SERVICE BULLETIN

No. 546

Piper Aircraft Corporation

Inspection of Whelen Wing Tip Strobe Lights;
Reference F.A.A. Airworthiness Directive
75-05-04

WHELEN NAVIGATION AND STROBE LIGHT ASSEMBLY

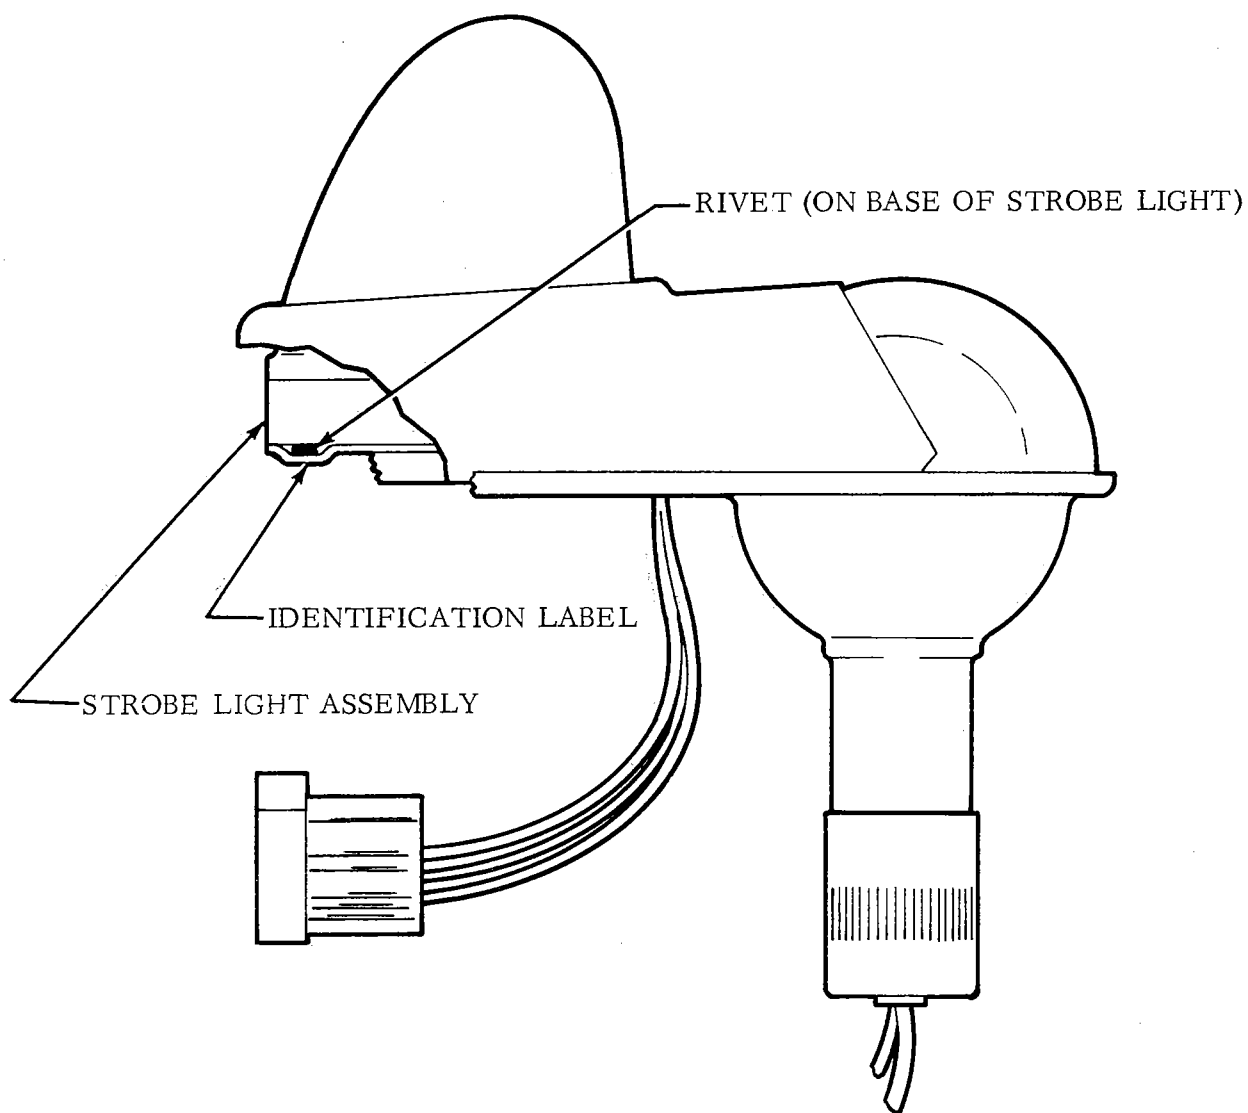
1. Expose wing tip strobe light assembly to view (refer to attached sketch for a typical strobe light assembly illustrated view).
2. If the following modification has already been accomplished, no further action is required; make appropriate entry in aircraft log book re compliance with this Service Release.

3. If the following modification has not been accomplished, proceed as follows:
 - a. Install on the base of the Whelen A-427 Flash Tube Assembly a pressure sensitive vinyl label conforming to Whelen drawing no. A-30052, Revision 1 dated October 15, 1974 or later F.A.A. approved revision.

1. Scotch Brand Type 33+ Vinyl Plastic electrical tape or equivalent tape - approved by an F.A.A. Maintenance/Avionics Inspector may be used in lieu of the vinyl label (if any plastic tape is used, it must be formed to cover the rivet at the rear of the flash tube without covering the identifying part number).

3. b. If the flash tube incorporates a label, the new label or tape may be installed directly over the old label.
- c. Install label or tape only when the label or tape and the flash tube are at a temperature above 50 degrees F.
4. Make appropriate service release compliance entry in aircraft log book.
